RE: **Tierra Serena (Glendesto) Subdivision**
Lots 15-20 - Accepted
Revised Grading Plan Stamp Date: 1/23/18
Certification Dated: 10/5/18
Hydrology File: B18D020

GLENDESTO SUBDIVISION
GRADING & DRAINAGE PLAN

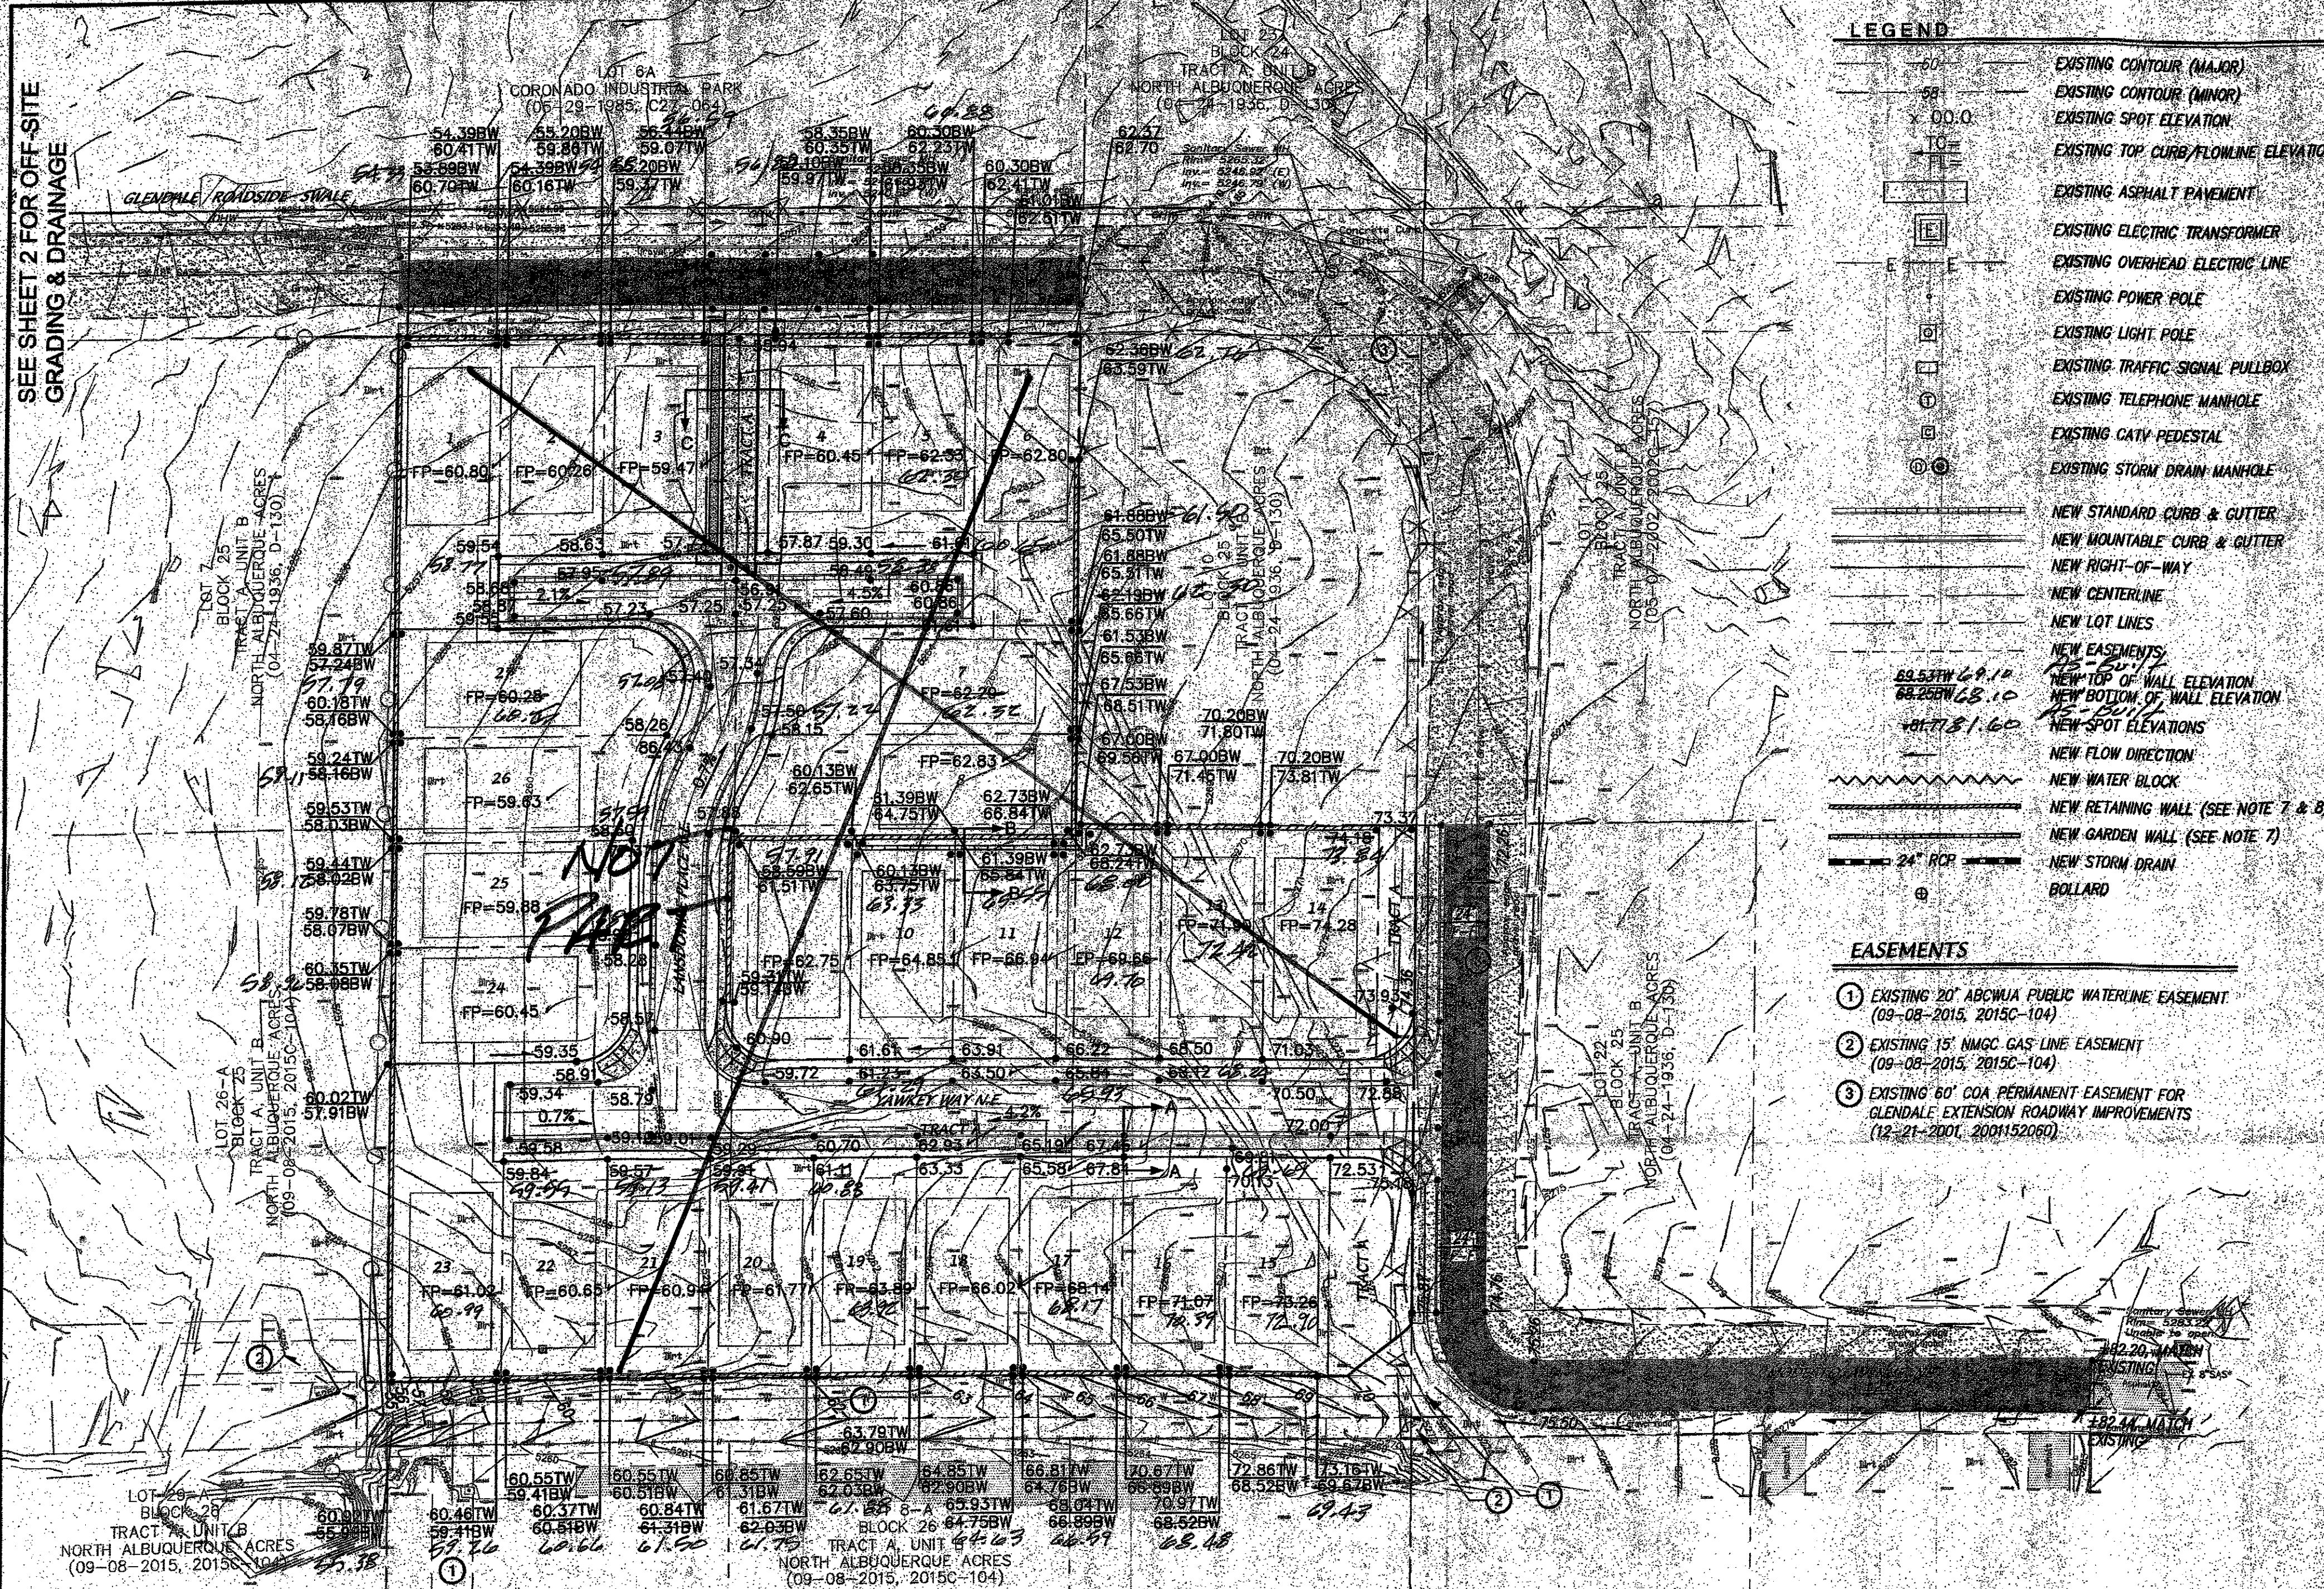
1. The Pad elevation is missing for Lot 14.
2. The parking lot needs to be removed prior to certifying Lot 14.

3. All survey data required per the DPM Ch 22.7: *Engineer's Certification Checklist for Subdivision* will need to be provided for Lots 5, 6, and 13.
4. The downstream storm water conveyance must be complete.
5. The water and gas easement behind lots 15-23 needs to be restored. Fill placed against the wood fence needs to be removed and this area needs to be reseeded and stabilized against erosion with check dams and gravel mulch.
6. All other offsite areas distributed as part of this project need to be restored and reseeded as well.
7. Additional comments can be expected at the time of ROFG, depending on future conditions at this site.
